UNITED STATES PATENT AND TRADEMARK OFFICE

Office Action Summary	Application No. 10/501,158	Applicant(s) THUROT, PHILIPPE	
	Examiner NATHAN A. BOWERS	Art Unit 1797

DETAILED ACTION

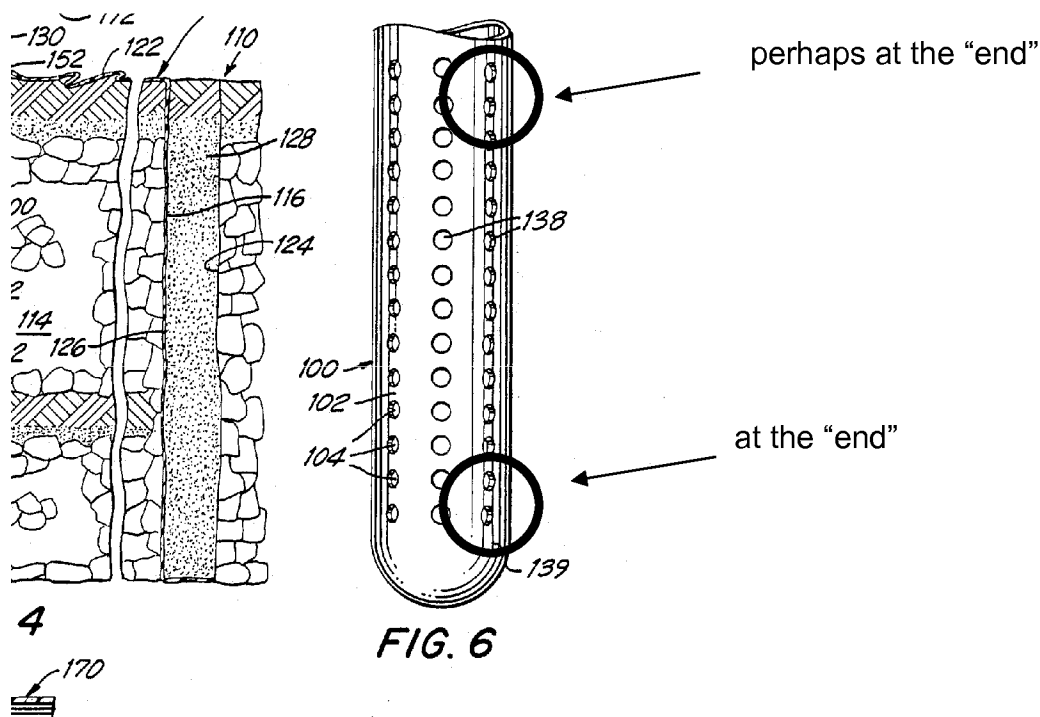
(a) The perforated tube of Katz is unsuitable for the sampling required of the present invention. The draw tube of Katz is engineered to outgas a large volume of

waste, and this is incompatible with the rapid measurement of oxygen content of several swaths.

(b) The Katz reference does not disclose an intake strainer at the end of each rod. The "end" of the Katz rod cannot be construed as including the lowermost strainers adjacent to the cap.

(c) Katz does not disclose a smooth sampling rod.

(d) There is no teaching in Yao of heating a zirconium oxide sensor in order to reduce response time.

Applicant has not provided any evidence suggesting that a draw tube engineered to outgas a large volume of waste would prove ineffective at monitoring the oxygen content of several swaths. Quite the opposite, draw tubes capable of removing large volumes of gas would provide a better indication of oxygen content within the processing waste by allowing for a larger sample size that is likely a better representation of the total gas within the waste. Indeed, Katz expressly teaches in column 2, lines 30-58 and in column 3, lines 12-40 that at least one remote bay (Figure 1:19) contains one or more gas measurement probes (Figure 2:10.1-10.5) that are capable of determining oxygen and carbon dioxide concentration.

Although it is agreed that Katz does not disclose air intake orifices on the rounded cap of the rod, the "end" of the rod is considered to extend an arbitrary distance along cylindrical sidewall of the rod from the rounded cap. The air intake strainers located immediately adjacent to the rounded cap are certainly located at the "end" of the rod.

The fact that Katz does disclose the use of air intake orifices all along the sidewalls of each rod does not mean that at least some of the orifices are located at the end of the rod.

Applicant's definition of "end" as "either extremity of something that has length" does not necessarily exclude surfaces along the sidewalls of the rod near the rod tip so long as they are adequately close to the tip. It is entirely possible that a feature (in this case a strainer) might be "adjacent" to the rod tip and still be considered at the "end" of the rod.

Schneider already discloses the use of smooth sampling rods. Katz is merely relied upon as evidence that it would have been obvious to fit air intake strainers at one end of the smooth sampling rods disclosed by Schneider.

Yao discloses that zirconium oxide sensors are well known in the art as effective means capable of monitoring oxygen concentrations within a gas stream. Additional limitations regarding heating constitute an *intended use* that does not alter the structure of the claimed apparatus.

In response to applicant's argument that Yao does not disclose heating a zirconium oxide sensor, a recitation of the intended use of the claimed invention must result in a structural difference between the claimed invention and the prior art in order to patentably distinguish the claimed invention from the prior art. If the prior art structure is capable of performing the intended use, then it meets the claim. In the instant case, the zirconium oxide sensor of Yao is fully capable of being heated.
